**March 25, 2025  
Addendum #1  
FOR IMMEDIATE ATTENTION**

Reference – Invitation for Bid:	IFB #017-0-2025/SNB Heritage High School Media Center HVAC Replacement
For Delivery To:	Newport News Public Schools
Bids Due:	April 4, 2025 at 2:00 PM EST

**ADDENDUM NO. 1**

**Media Center HVAC System Replacement  
Heritage HS  
IFB # 017-0-2025/SNB  
Newport News, Virginia  
MJT #23-066**

**CP1.1**

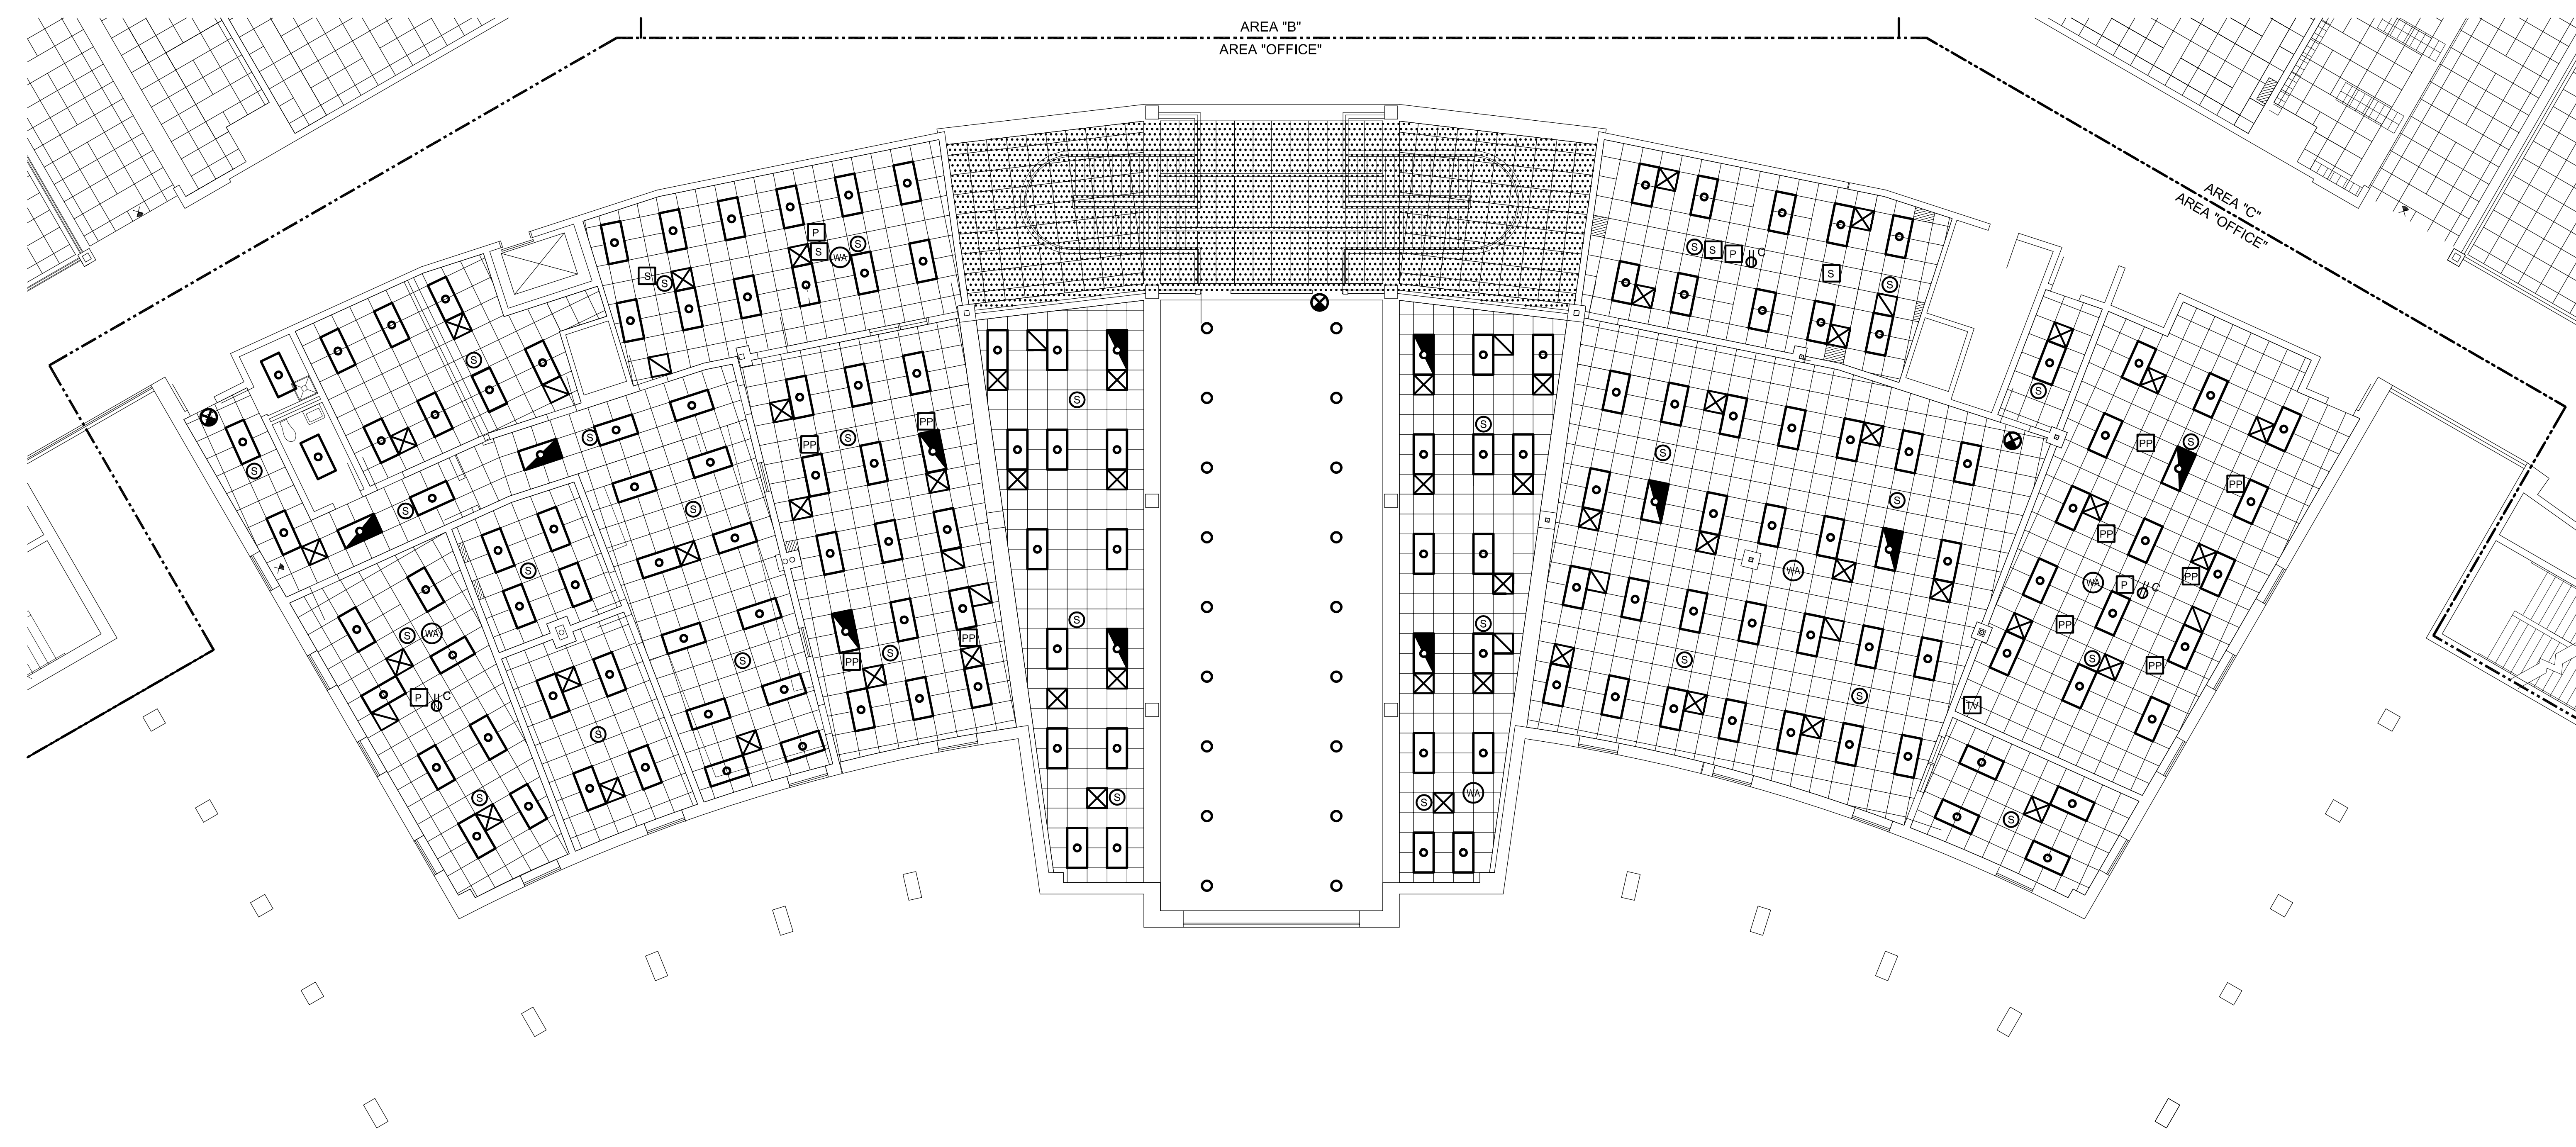
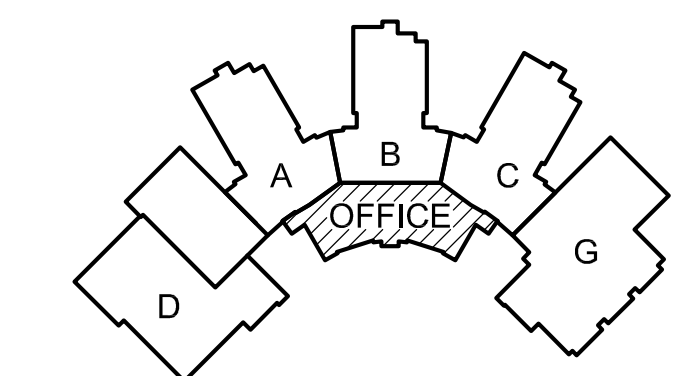
**Drawing CP1.1:** ADDED "Second Floor Plan – Area Media Center – Reflected Ceiling Plan" sheet. Refer to the attached drawings.
